Reference: Engineering Services
105 Meadow Spring Ln.
Sanford, NC 27332
TE&D Project No.: 2301-020195-R

As requested by the builder, a representative of Tyndall Engineering & Design, PA (TE&D) was on-site to observe the following items:

Item 1.b. Install additional 2 x 4 studs packed tightly to corners

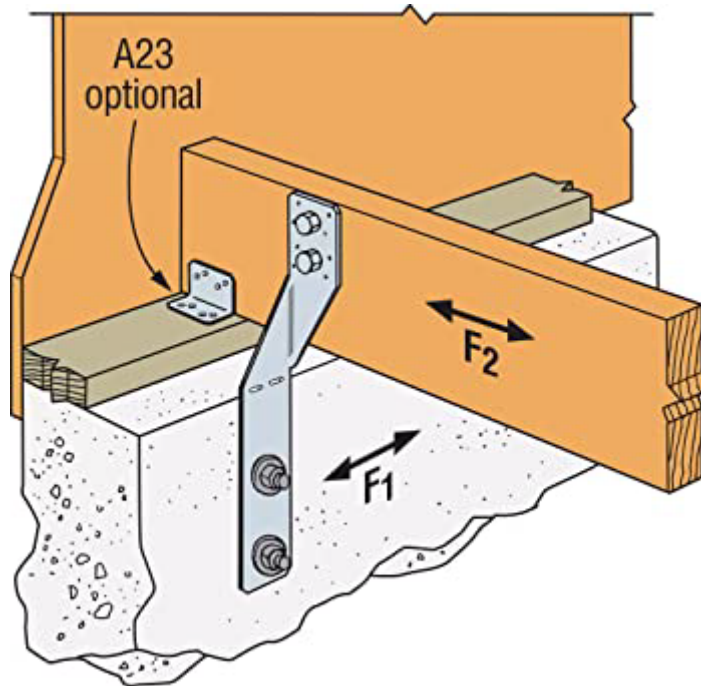
- 1) The exterior walls of the sunroom addition do not comply with the portal framing requirements of the 2018 NC Residential Building Code.
- 2) The 2 x 8 joists were notched to bear on the LVL beam.

- b. Additional stud columns are to be packed tightly into open space between the windows and the corners.
 - c. The interior of all exterior walls is to be covered with 7/16" structural sheathing. Sheathing is to be secured to all studs and headers with 8D nails at 8" o.c.
